northern beaches council
PLANS APPROVED BY THE LAND AND ENVIRONMENT COURT OF NSW
PROCEEDINGS NO: 2023/238892
DATED: 5 June 2024

FOR S4.55 (8) APPLICATION

PROJECT:
PROPOSED SENIORS LIVING
4 ALEXANDER ST, COLLAROY
NSW

DA101
LEVEL 1 PLAN
ISSUE: **G**
SCALE: **1 : 100**

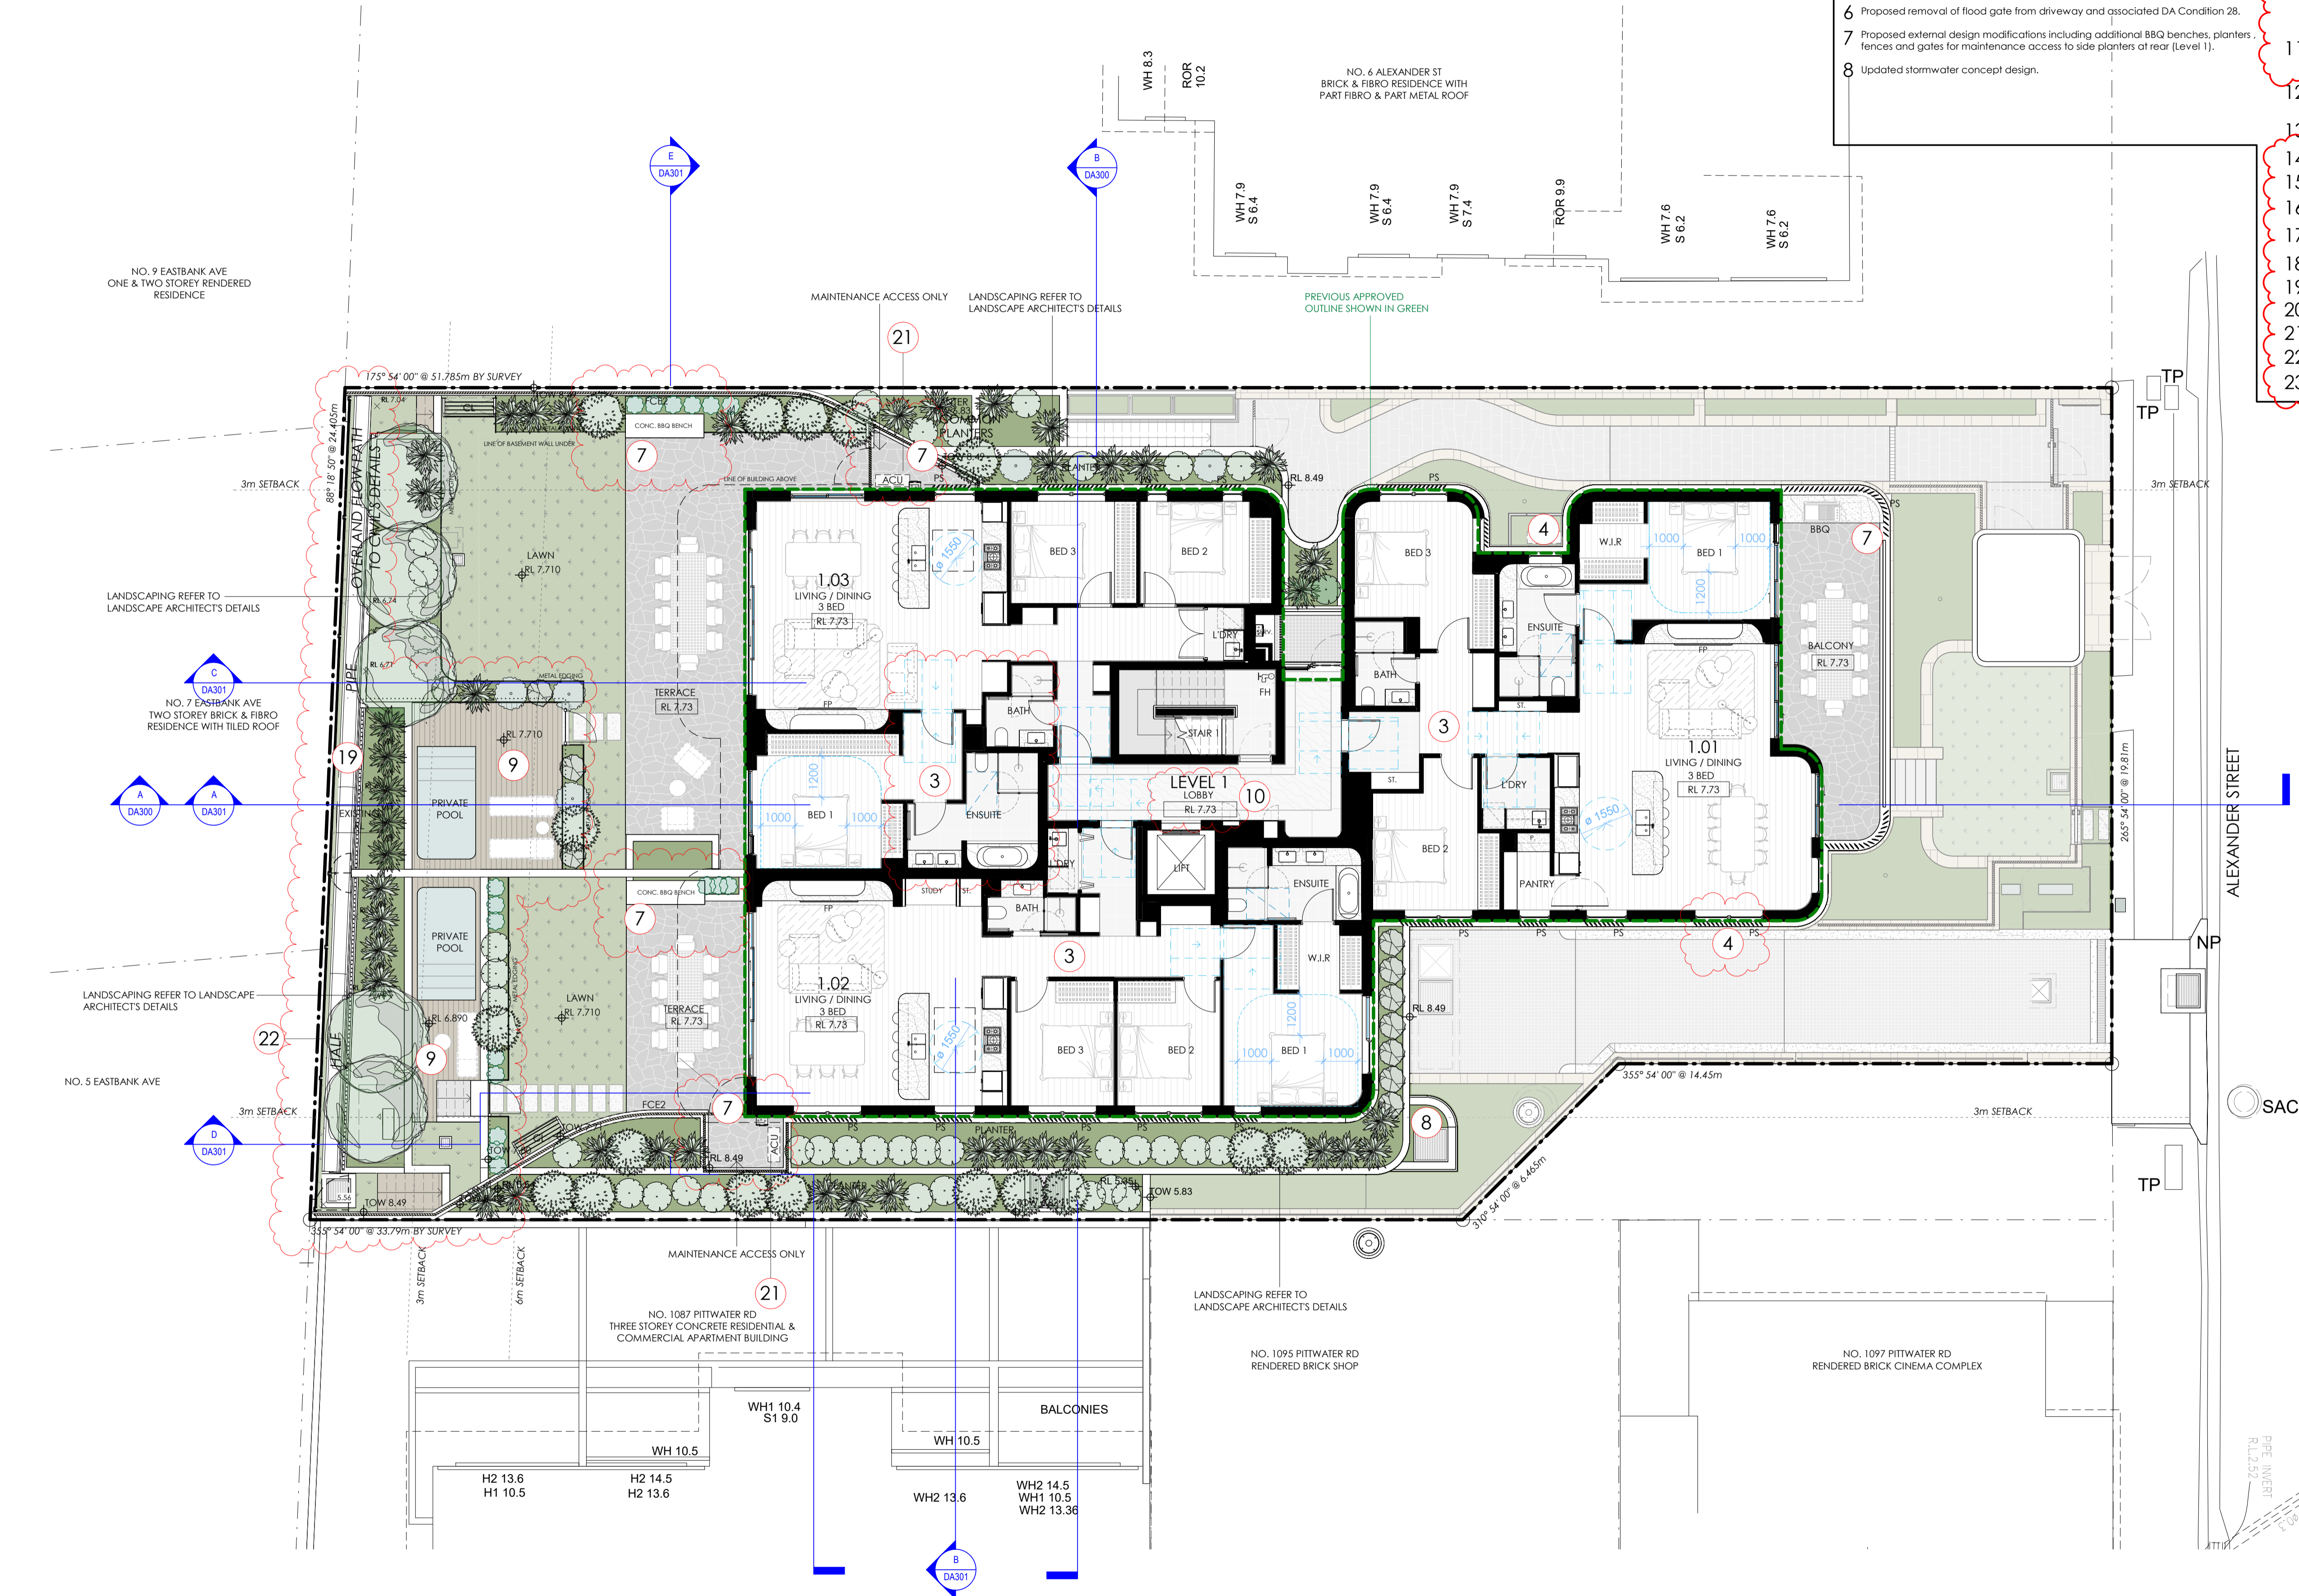
- PROPOSED MODIFICATION ITEM NO. REFER TO LIST BELOW
- Proposed modifications to skylights including deletion of 2 skylights over unit 2.01, and updated sizes of skylights over Unit 1.02 & 1.03.

- Additional storage room at basement level.
- Updated interior layout generally.
- Modification to facade windows openings and configurations generally.

- Additional metal framed louvre awning to Level 2.
- Proposed removal of flood gate from driveway and associated DA Condition 28.
- Proposed external design modifications including additional BBQ benches, planters, fences and gates for maintenance access to side planters at rear (Level 1).

- Updated stormwater concept design.
- Associated landscape design update including:
 - a) Level 1: proposed updated overland flow path based on civil eng.'s assessment

- b) Level 1: proposed 2 additional private plunge pools at rear
 - c) Level 1: Revised boundary fencing height and design at rear
 - d) Level 1: Revised external levels

- e) Level 1: Revised external backyard
 - f) Ground floor: Revised front garden design to G.01 and around OSD tank area
- Proposed building height increase including adjustments to floor levels to:

- Level 1: RL 7.73
 - Level 2: RL 11.03
 - Roof: RL 14.25
- Updated roof layout including adjustment to lift overrun structure, services layout and photovoltaic panels. Proposed deletion of DA Condition 8 as part of the proposed amendments at roof level.

- Updated extent of shoring and retention generally.
- Modification to proposed car parking arrangement and number of car space.
- Adjustment to level 2 envelope shifting towards west generally.

- Frosted glazing to level 2 ensuite window
- Proposed removal of topmost roof overhang and revision to the perimeter parapet detail.
- Amended landscape design at level 2 including additional planters and increase southern edge to 1m width.

- Privacy screen to eastern edge of level 2 balcony at rear.
- Updated overland flow path design.
- Updated lift overrun level.
- Updated roof layout to relocate AC units to lower levels.

- Updated fence height to southern boundary
- Proposed 300mm shoring wall setback from boundary with additional planters to landscape architect's details

LEVEL 2 PLAN

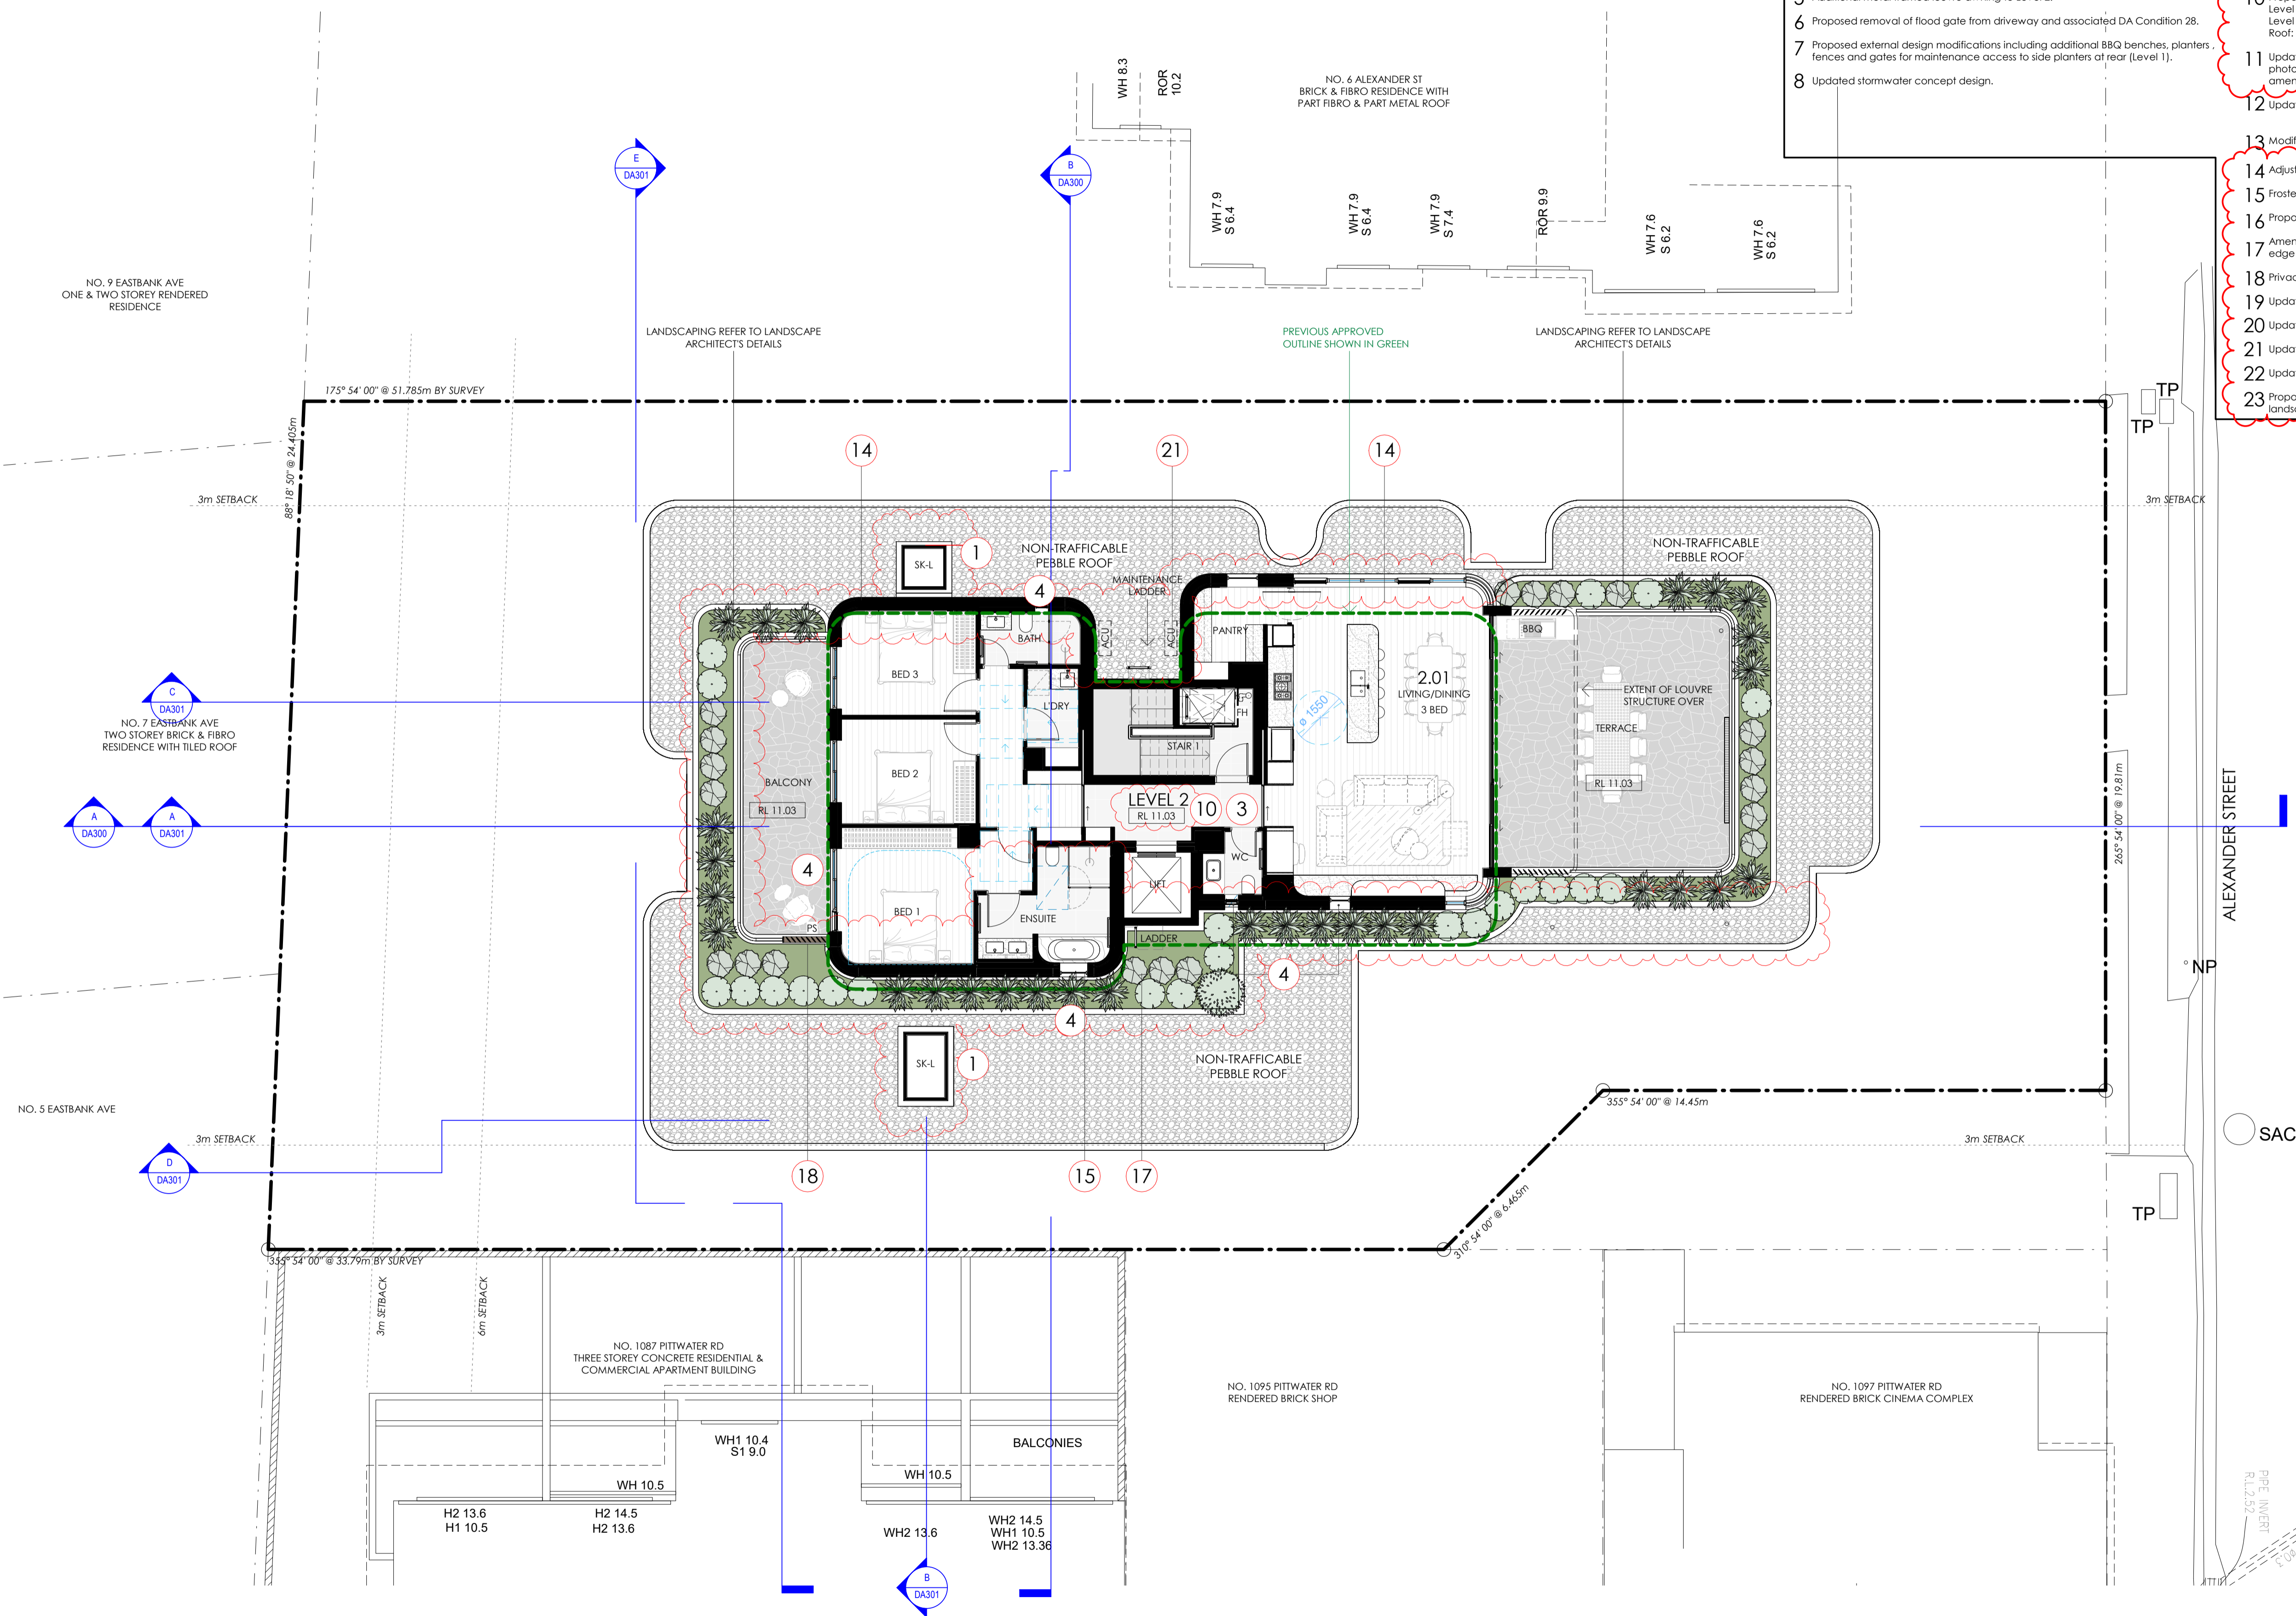
- PROPOSED MODIFICATION ITEM NO. REFER TO LIST BELOW
- Proposed modifications to skylights including deletion of 2 skylights over unit 2.01, and updated sizes of skylights over Unit 1.02 & 1.03.

- Additional storage room at basement level.
- Updated interior layout generally.
- Modification to facade windows openings and configurations generally.

- Additional metal framed louvre awning to Level 2.
- Proposed removal of flood gate from driveway and associated DA Condition 28.
- Proposed external design modifications including additional BBQ benches, planters, fences and gates for maintenance access to side planters at rear (Level 1).

- Updated stormwater concept design.
- Associated landscape design update including:
 - a) Level 1: proposed updated overland flow path based on civil eng.'s assessment

- b) Level 1: proposed 2 additional private plunge pools at rear
 - c) Level 1: Revised boundary fencing height and design at rear
 - d) Level 1: Revised external levels

- e) Level 1: Revised external backyard
 - f) Ground floor: Revised front garden design to G.01 and around OSD tank area
- Proposed building height increase including adjustments to floor levels to:

- Level 1: RL 7.73
 - Level 2: RL 11.03
 - Roof: RL 14.25
- Updated roof layout including adjustment to lift overrun structure, services layout and photovoltaic panels. Proposed deletion of DA Condition 8 as part of the proposed amendments at roof level.

- Updated extent of shoring and retention generally.
- Modification to proposed car parking arrangement and number of car space.
- Adjustment to level 2 envelope shifting towards west generally.

- Frosted glazing to level 2 ensuite window
- Proposed removal of topmost roof overhang and revision to the perimeter parapet detail.
- Amended landscape design at level 2 including additional planters and increase southern edge to 1m width.

- Privacy screen to eastern edge of level 2 balcony at rear.
- Updated overland flow path design.
- Updated lift overrun level.
- Updated roof layout to relocate AC units to lower levels.

- Updated fence height to southern boundary
- Proposed 300mm shoring wall setback from boundary with additional planters to landscape architect's details
